## Everest Core-Board Revision History

Document Number 108-0141-001

**Silicon Graphics, Inc.  
Mountain View, California**

**Figure 4-1** IO4 History Diagram

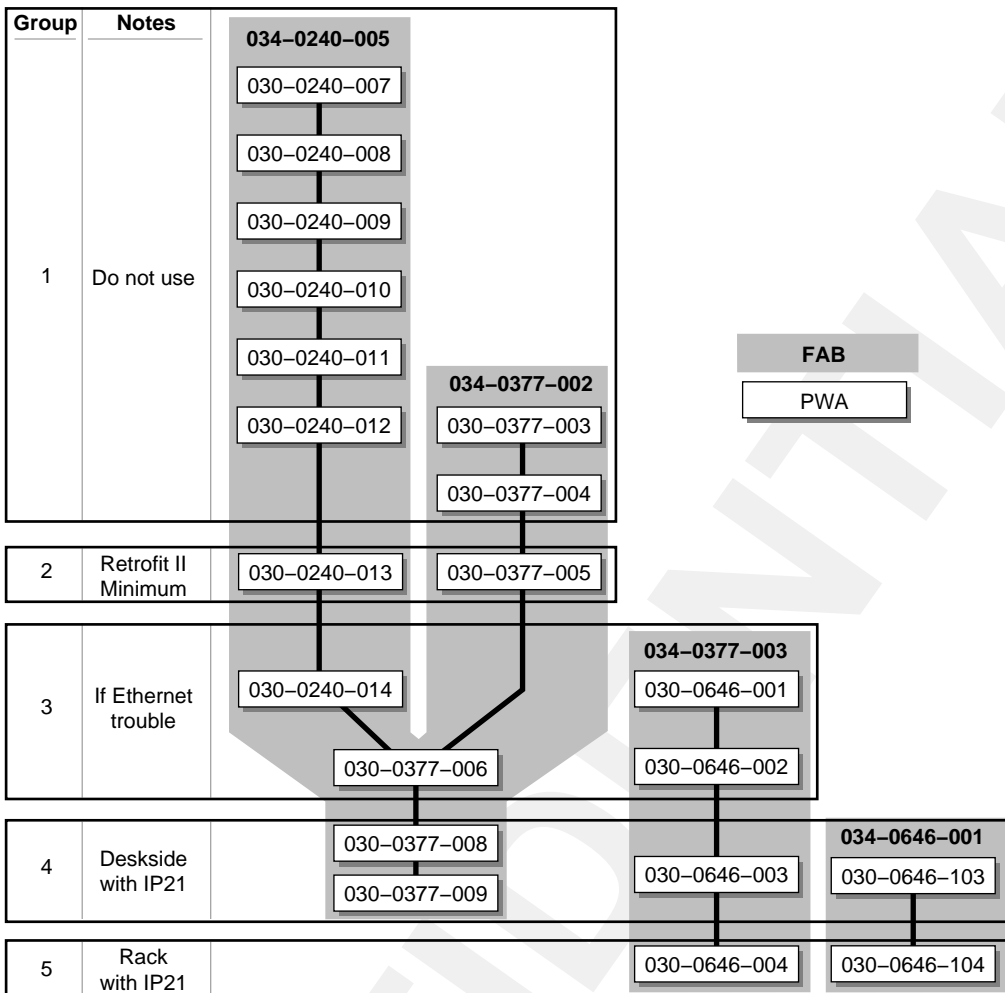
The most significant changes made to the IO4 line came with the 034-0377-003 FAB. This new FAB implemented two changes: the addition of a +12V supply to the mezzanine connectors and the addition of support for a dual-hosted SCSI bus. In honor of this change, the IO4 got a new base number (making it 030-0646-xxx), and a new name (it is officially called the "IO4B").

Table 4-1 [Figure 4-2](#) shows which FABs each IO4 board is based on. Note that the 030-0377-006 through 030-0377-009 IO4 boards may be based on either the 034-0240-005 FAB or the 034-0377-002 FAB. This can be a point of confusion in dealing with IO4 boards.

Group 1 (in Table 4-1 [Figure 4-2](#)) is included only for historical purposes. These boards should no longer be in use in the field.
